**STAFF REPORT:** 11/8/2023 REGULAR MEETING  
**APPLICATION NUMBER:** HDC2023-00091  
**VIOLATION NUMBER:** 790  
**ADDRESS:** 14833 STAHELIN  
**HISTORIC DISTRICT:** ROSEDALE PARK  
**APPLICANT/ PROPERTY OWNER:** TAMEKKA COLMAN  
**DATE OF PROVISIONALLY COMPLETE APPLICATION:** 10/16/2023  
**DATE OF STAFF SITE VISITS:** 9/21/2023, 10/19/2023

**SCOPE:** DEMOLISH GARAGE, ERECT GARAGE, ALTER DRIVEWAY/PAVING (WORK COMPLETED WITHOUT APPROVAL)

*Aerial#2 by Google Earth June 2023, showing original garage demolished existing driveway expanded along with new rear deck.*

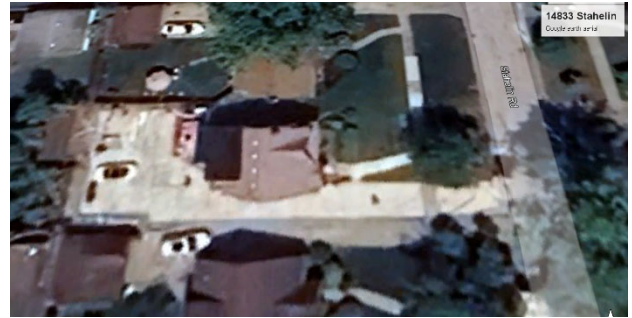
- Staff initially received an application for only the removal of the original garage and installation of the new driveway, but upon further engagement with the applicant, there appears to be additional work completed without approval, the installation of a rear deck, which is visible in Google Earth imagery and confirmed by the applicant. Staff, however, did not receive any further information from the applicant and so this work is not included in this application. (See aerial #1&2)

- Although site photos of the rear were not obtained by the completion of this report, staff observed that the rear yard appears to be nearly covered in concrete from aerial images (*See Aerial #2*). This and the garage leaves only 3' to 7' margin of grass around the garage but eliminates the backyard lawn.

Site Photo 4, by Google Street View June 2019, showing original driveway width and planting beds next to the house.

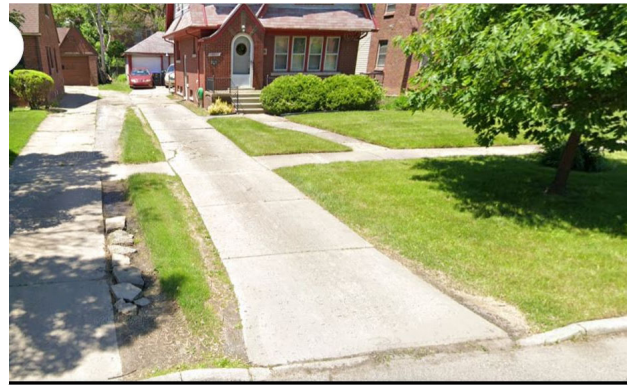
- Staff observed that the new driveway, constructed without approval, is approximately 2 feet wider than the original driveway, which overlays on top of the previously present green space between the house and the driveway, thus creating a continuous hard surface that nearly joins the neighbor’s driveway to the rear. Staff has the opinion that the width of the new driveway is not appropriate because it conflicts with the Elements of Design’s Relationship of Significant Landscape Features and Surface Treatments, *“The front lawn area is generally covered with grass turf, subdivided by a straight or curving concrete or brick walk leading to the front entrance and a single-width side driveway leading to a garage.”* (See site photo 4)

Aerial #3 of Rosedale Park HD, showing applicant’s location in the context of other resident’s back yards.

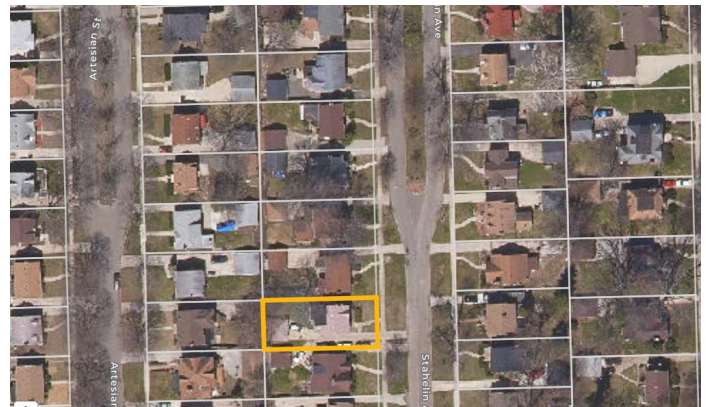
- A review of aerial images of the district revealed that most of the space within rear yards is typically dedicated to grass turf/landscaped open lawns with minimal hardscape intrusions to include walkways, patio, and narrow driveways. (See Aerial #3) When detached garages are present within the district, staff noted that parcels typically include a structure of a footprint/scale that is minimal in relationship to the home, leaving ample open green space in the rear yard. The current project will result in the erection of a large garage and expansion of the driveway that results in the near complete removal of the open lawn space within the rear yard. It is staff’s opinion that these conditions are incompatible with the house’s and the district’s historic character.
